# Comment #41: Effects of the change from $N_p=13$ to $N_p=200$

Yasuo Hidaka  
Fujitsu Laboratories of America, Inc.

IEEE P802.3bs Task Force  
Electrical Ad hoc, October 24, 2016

# Steady-State Voltage $v_f$ ( $z_p=30\text{mm}$ )

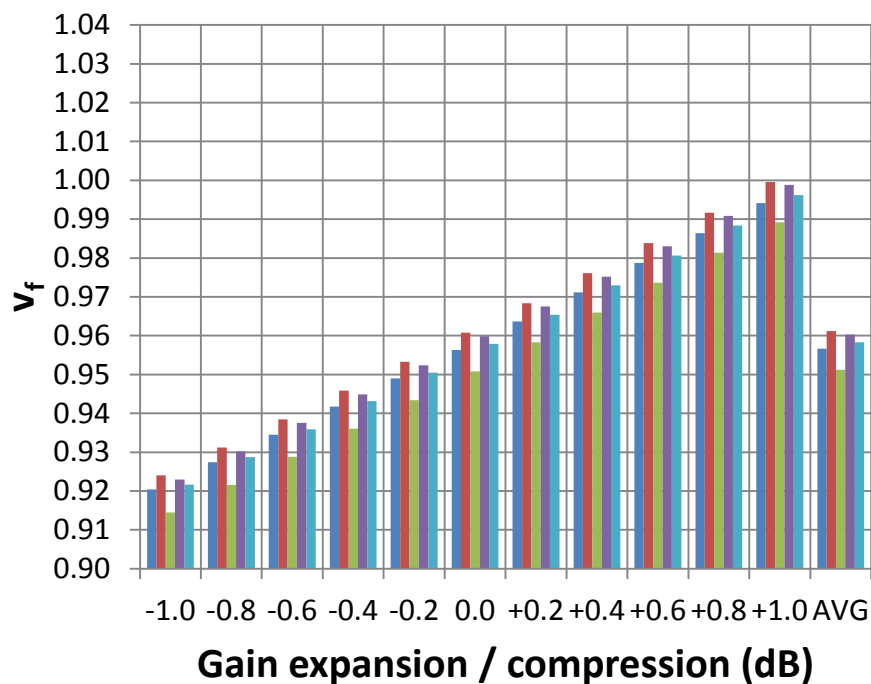
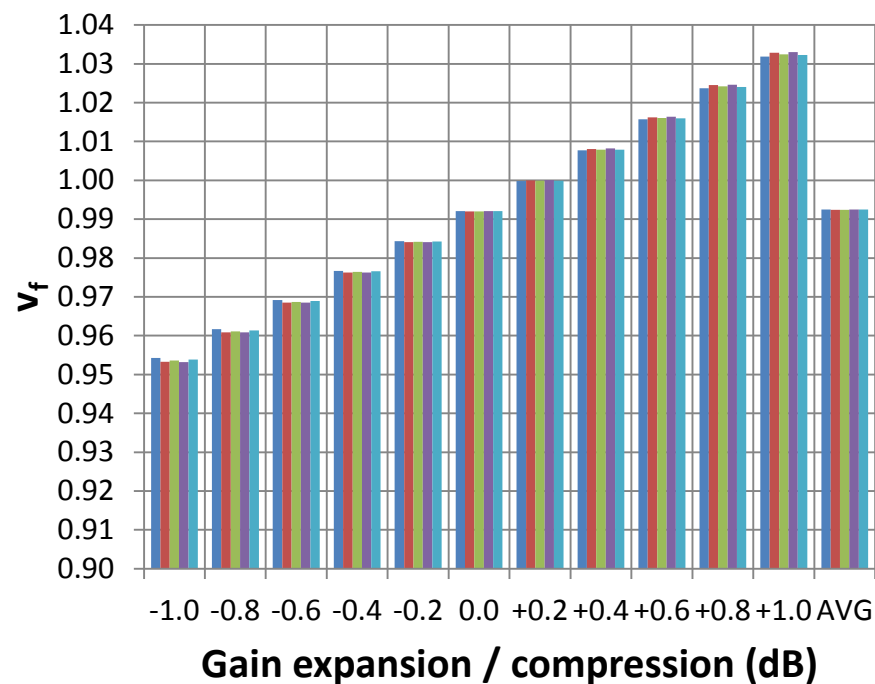
## ■ Non-negligible increase

■ Because a longer fitted pulse captures more long-term ISI

# Steady-State Voltage $v_f$ ( $z_p=12\text{mm}$ )

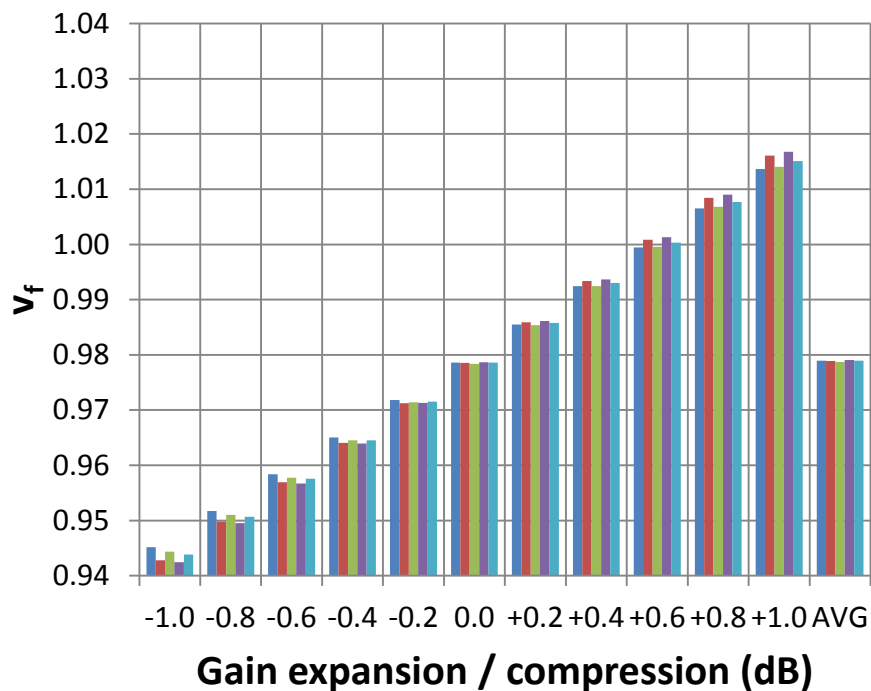
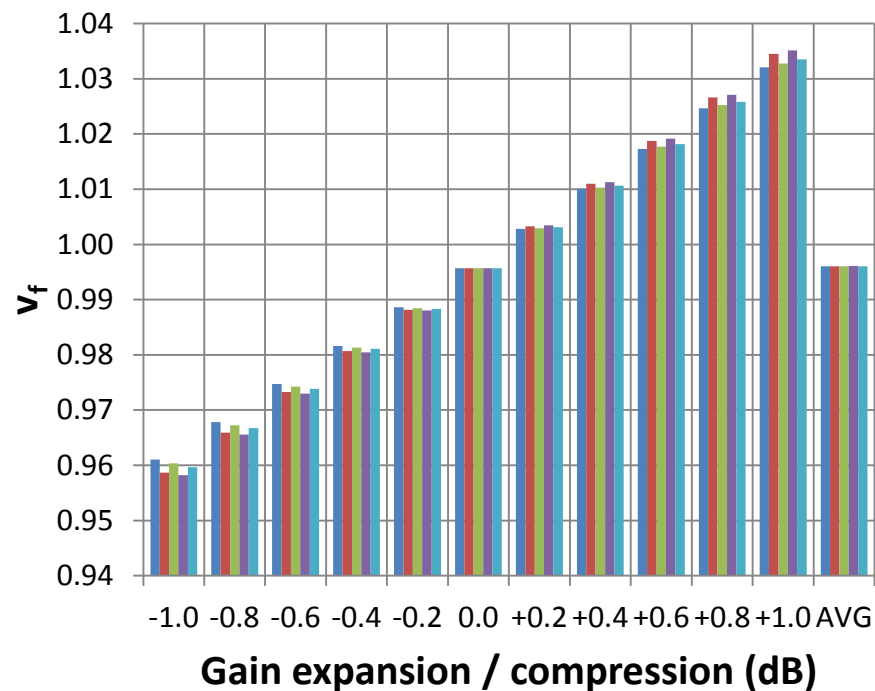
## ■ Non-negligible increase

■ Because a longer fitted pulse captures more long-term ISI

# Ratio of $p_{\max}$ to $v_f$ ( $z_p=30\text{mm}$ )

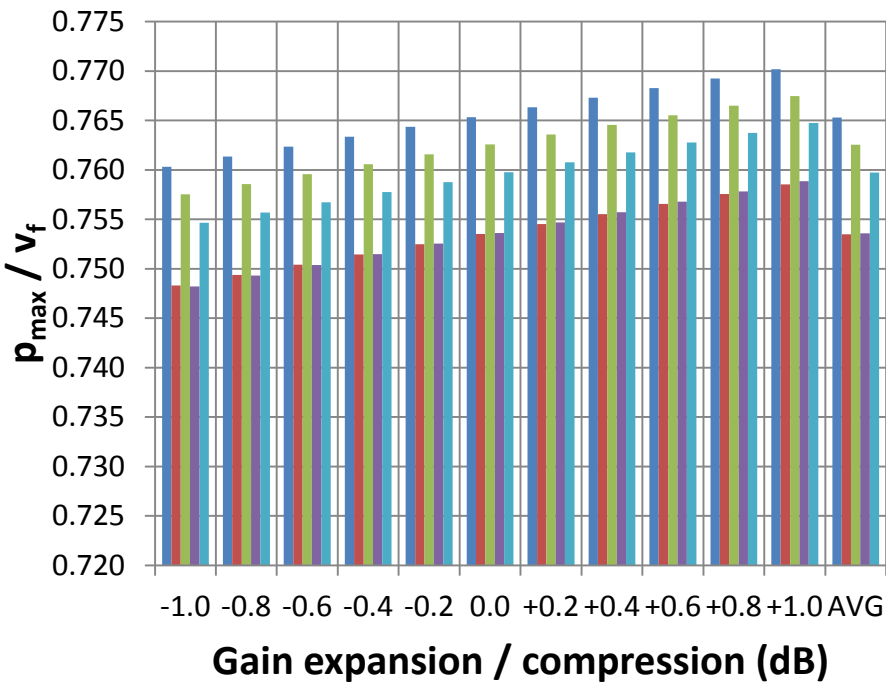
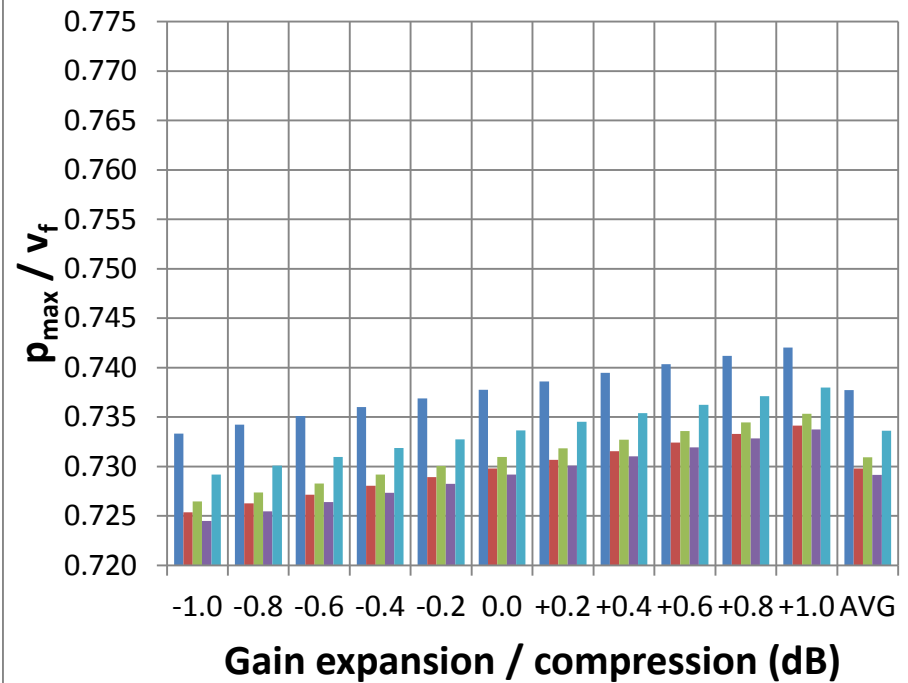
## ■ Reduced

■ Because  $v_f$  increases while  $p_{\max}$  does not change

# Ratio of $p_{\max}$ to $v_f$ ( $z_p=12\text{mm}$ )

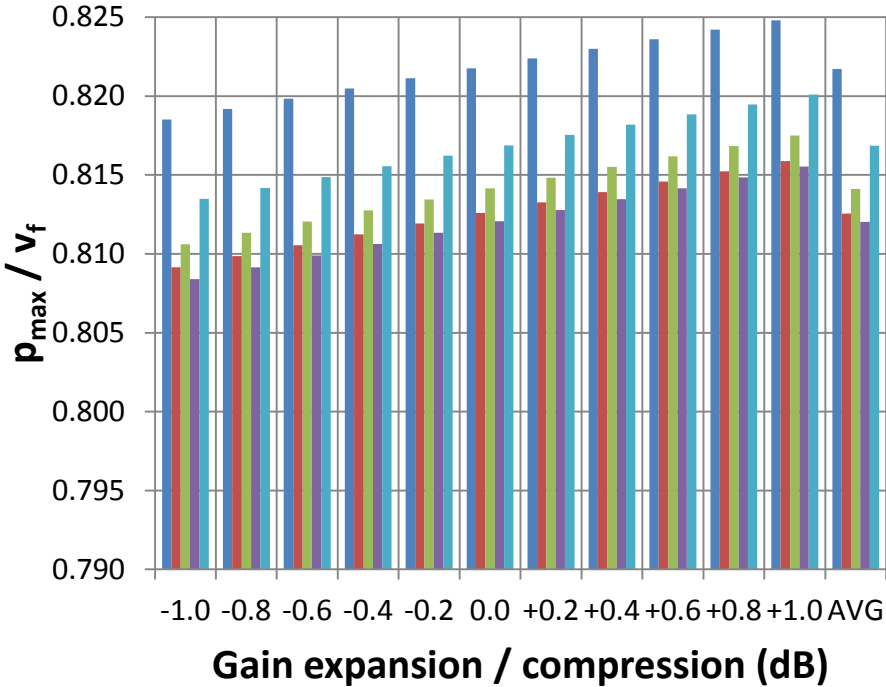
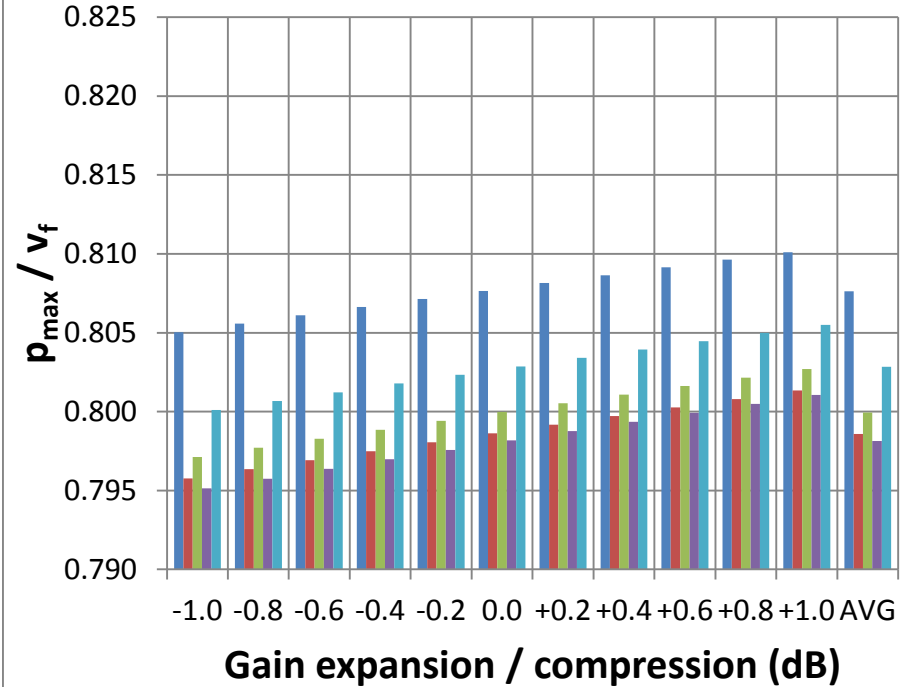
## ■ Reduced

■ Because  $v_f$  increases while  $p_{\max}$  does not change

# Change of Steady-State Voltage $v_f$

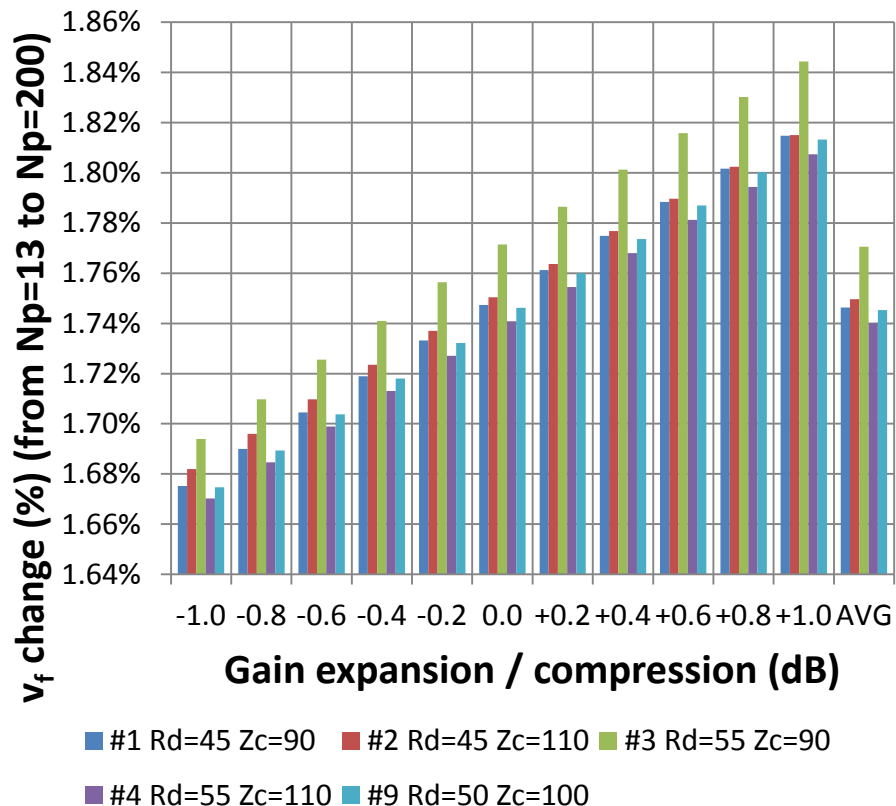
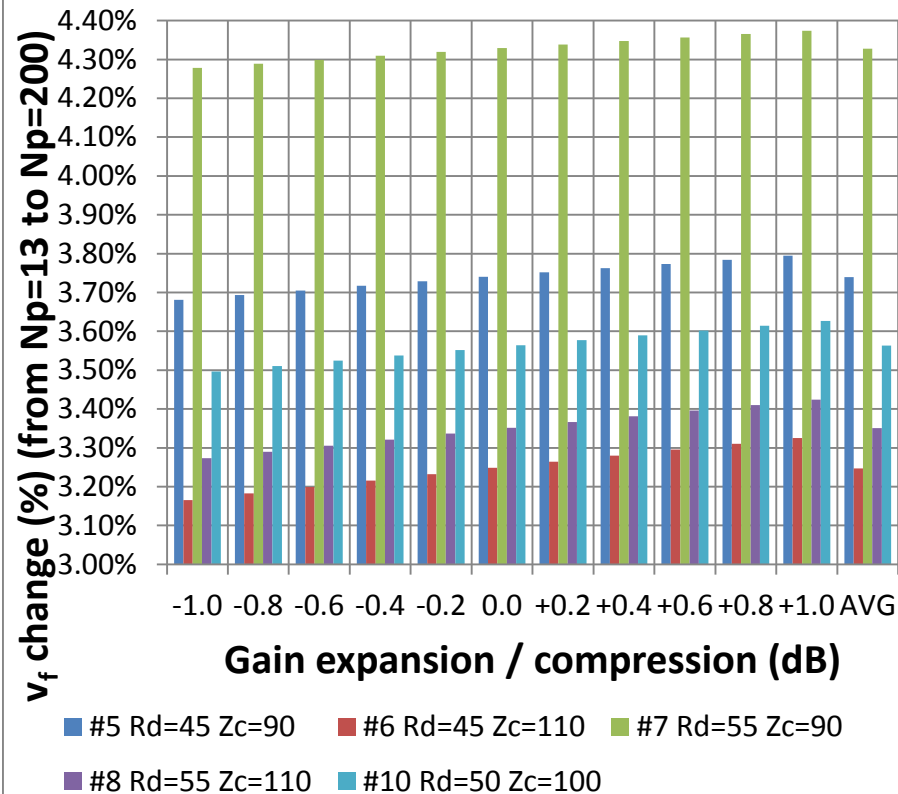
Condition	#3 (Rd=55, Zc=90)	AVG (#1,2,3,4,9)
Change	+1.7706%	+1.7504%
0.6V (max) in D2.1	0.61062	0.61050

Condition	#7 (Rd=55, Zc=90)	AVG (#5,6,7,8,10)
Change	+4.3279%	+3.6456%
0.4V (max) in D2.1	0.41731	0.41458

- Recommended changes based on the results for #3 and #7
  - Change the Steady state voltage  $v_f$  (max)
    - from 0.6 V to 0.611 V
  - Change the Steady state voltage  $v_f$  (min)
    - from 0.4 V to 0.417 V
  - Change the Linear fit pulse peak (min)
    - from  $0.736 \times v_f$  to  $0.705 \times v_f$

- Or, recommended changes based on the average results
  - Change the Steady state voltage  $v_f$  (max)
    - from 0.6 V to 0.611 V
  - Change the Steady state voltage  $v_f$  (min)
    - from 0.4 V to 0.415 V
  - Change the Linear fit pulse peak (min)
    - from  $0.736 \times v_f$  to  $0.710 \times v_f$

# Change of Ratio of $p_{\max}$ to $v_f$

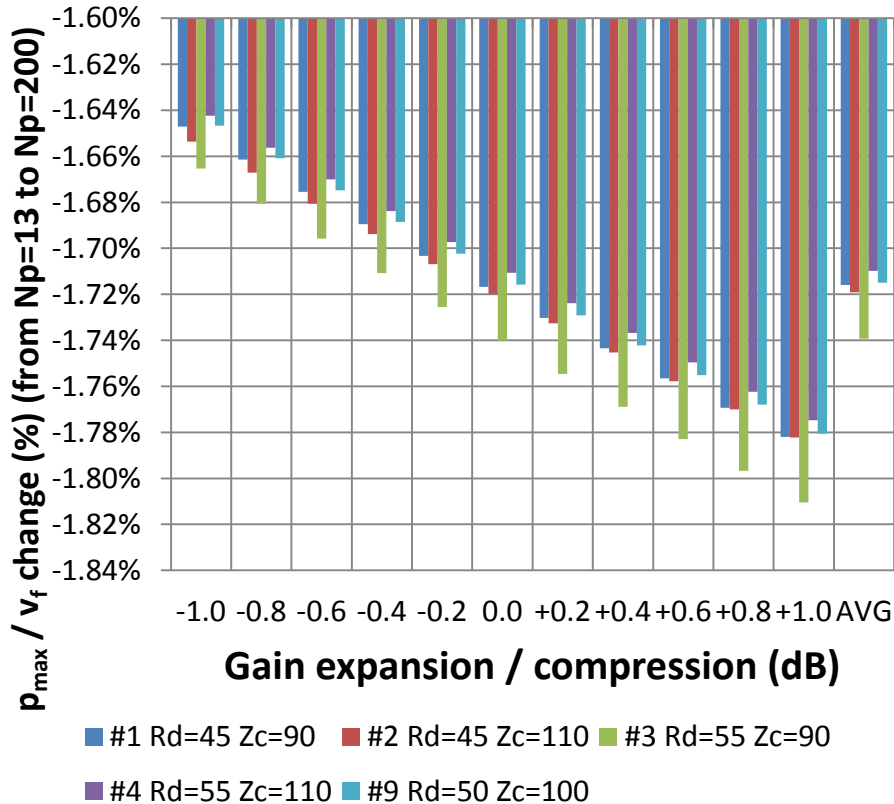
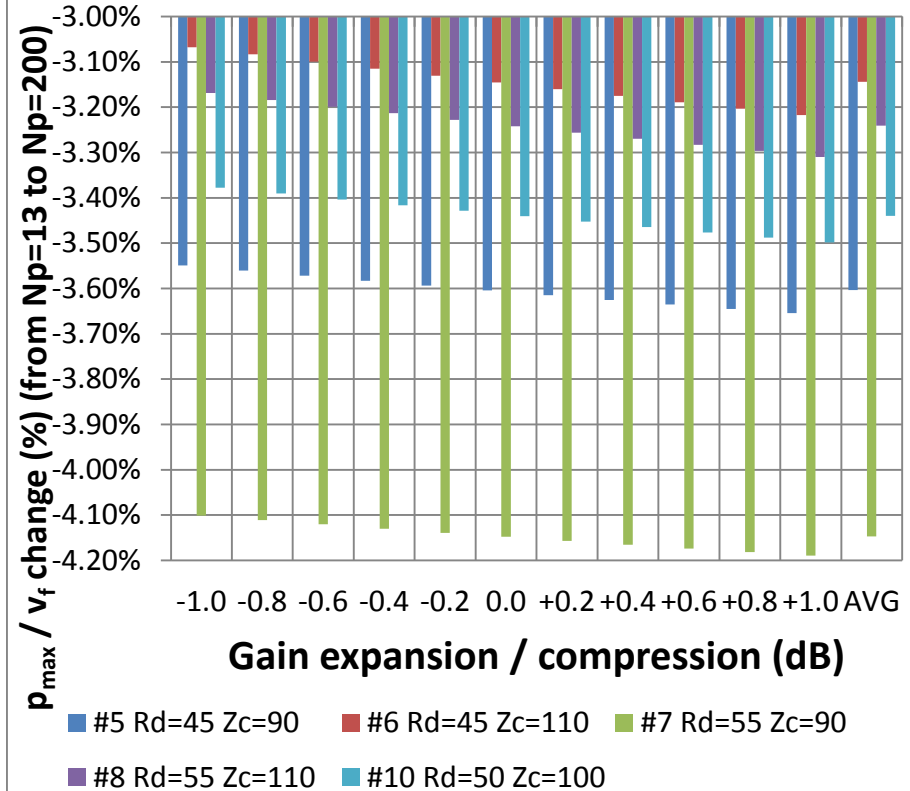
Condition	#3 (Rd=55, Zc=90)	AVG (#1,2,3,4,9)
Change	-1.7393%	-1.7198%

Condition	#7 (Rd=55, Zc=90)	AVG (#5,6,7,8,10)
Change	-4.1471%	-3.5151%
0.736 (min) in D2.1	0.705477	0.710129
